Appendix M – Agency Scoping Comments

Subject: Environmental Impact Statement Scoping for the CTA Red Line Extension

Reference is made to your interagency scoping meeting on September 24, 2009, concerning the subject matter. The Metropolitan Water Reclamation District of Greater Chicago (District) has the following comments for the scoping process:

THE SANITARY DISTRICT OF CHICAGO
 CALUMET INTERCEPTING SEWER
 CONTRACT NO. 1886-7
 GENERAL LOCATION PLAN
 MAY 1916

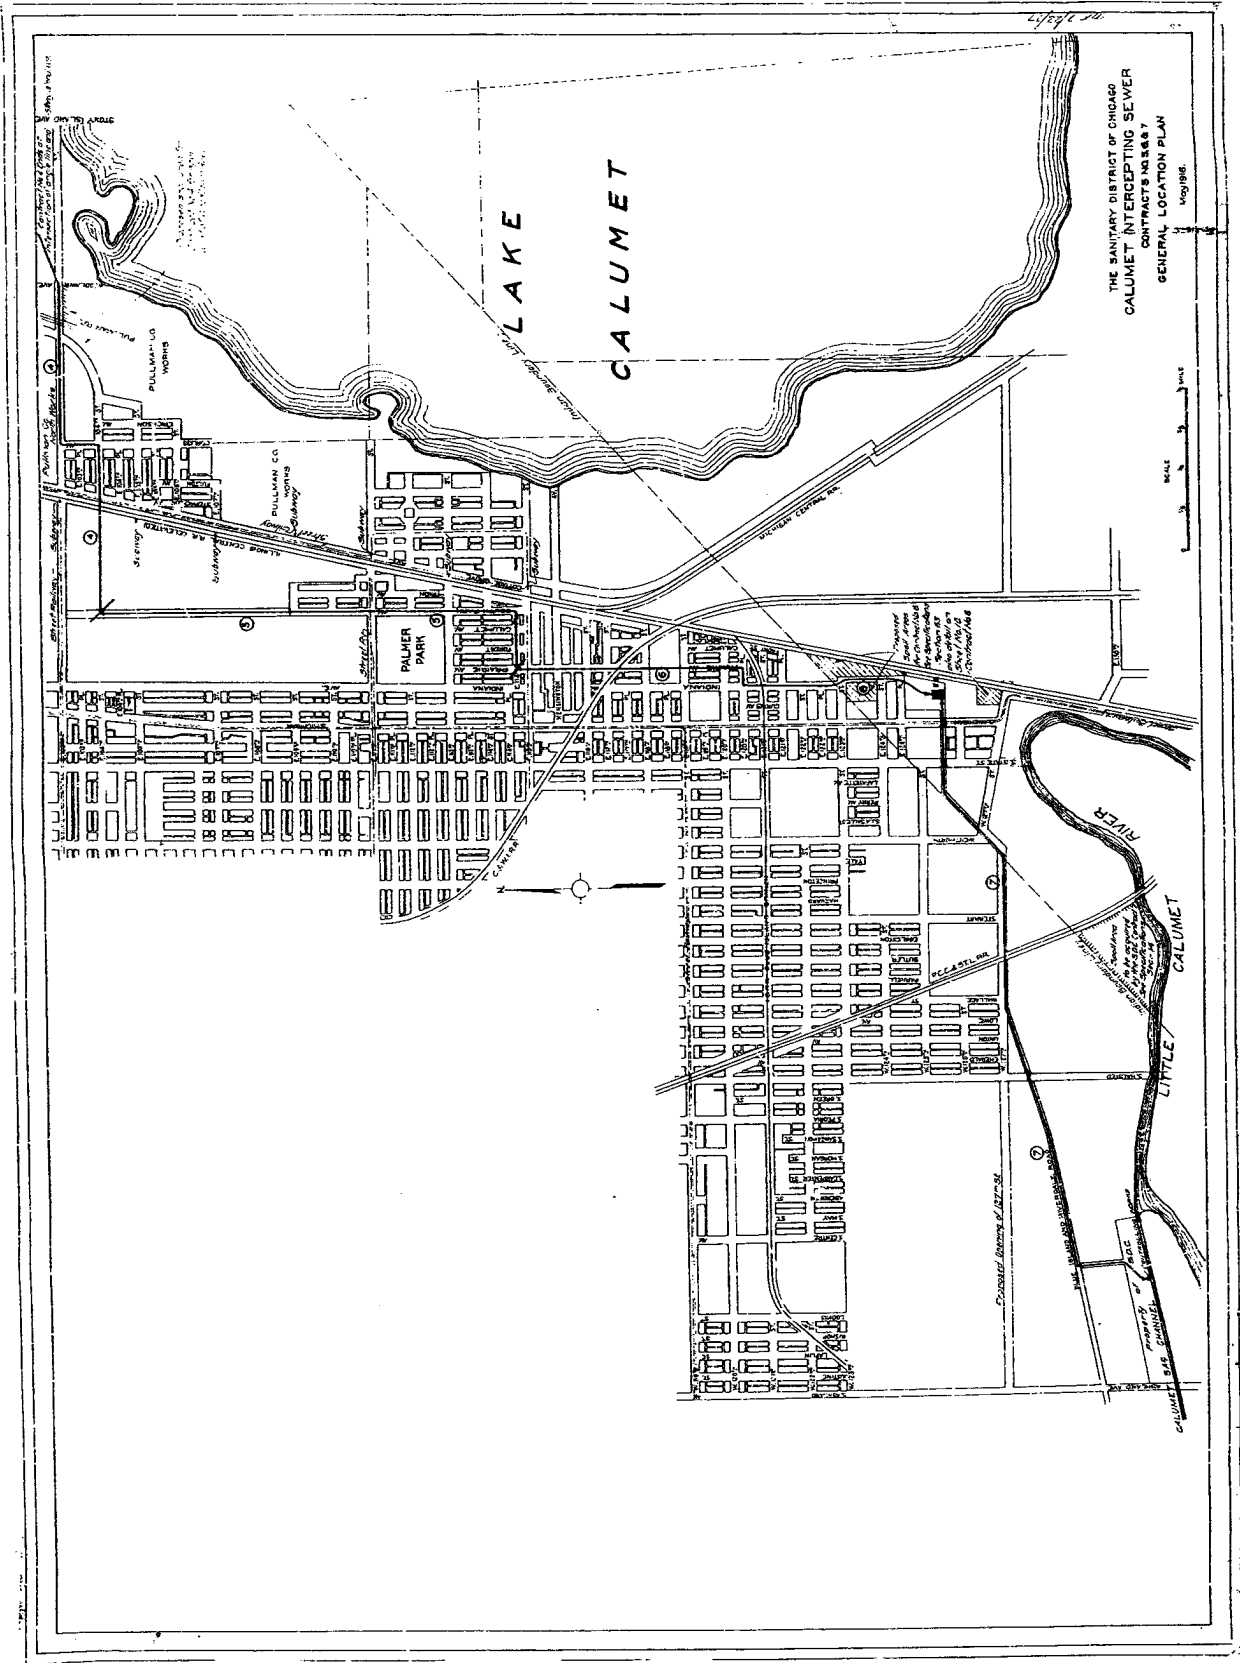
- We recommend an odor study be conducted early in the environmental review process for impacts on the proposed CTA facilities. The area of greatest concern is the final CTA station along 130th Street, which is directly adjacent to the Calumet Water Reclamation Plant.
- The proposed alignment crosses the District's 17'6"x14'0" Calumet Intercepting Sewer 6 just east of Indiana Avenue. Attached are Sheets 1 and 5 of this contract. This intercepting sewer should be placed on all future Red Line Extension plans.
